Urgent Field Safety Notice

StealthStation™ S8 App version 2.0 and 2.0.1 (Model # 9735762)

StealthStation™ S8 and StealthStation FlexENT™ Software Plan Data Shift with New Reference Exam Notification and warning & instructional placard placement

Medtronic Reference: FA1361

Figure 3. Pre-Merge/Diffusion Merge with Reference

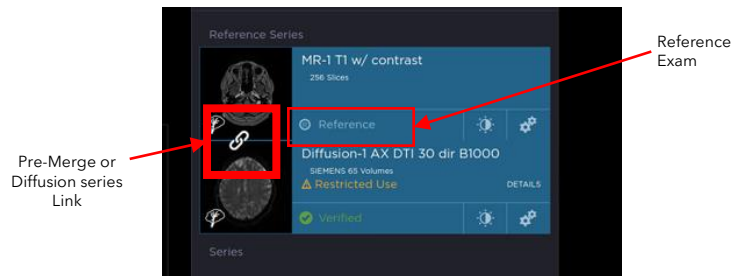
1. The navigation reference exam is merged with either a diffusion series (for tractography processing) or a pre-merge type series (an exam that does not contain anatomical information that must already be aligned or pre-merged to the anatomy in the reference exam - examples are a functional MRI activation map overlay or a PET exam).

Note: The icon link in **Figure 3**, below indicates the use of pre-merge or diffusion merge. Merged images without this icon link is not impacted by this anomaly.

Medtronic recommends that users do not change the reference exam after establishing a surgical plan if the original reference exam included pre-merge or diffusion merge exam. The incorrect surgical plan data **cannot** be recovered by reverting to the original reference exam. To resolve this issue, the user must manually update the existing plans to the original locations or make new plans.

Figure 4. Pre-Merge/Diffusion Merge with changed Reference

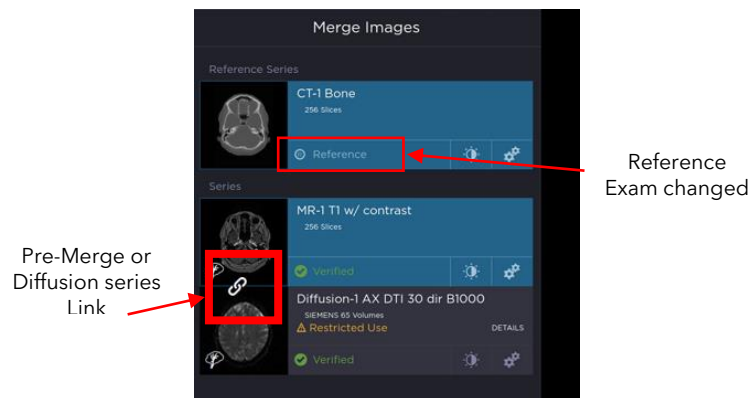
2. Surgical planning data (surgical plans, annotations, or AC-PC data) is established based on the reference exam with the Pre-Merge or Diffusion Merge exams.
3. The reference exam is changed to a different exam as seen in **Figure 4**, below.

In accordance with the IFU: Verify that a plan's target point, entry point, and trajectory are clinically valid before using it for a procedure. Traverse the surgical plan to check the entry, target, and trajectory after any edit.
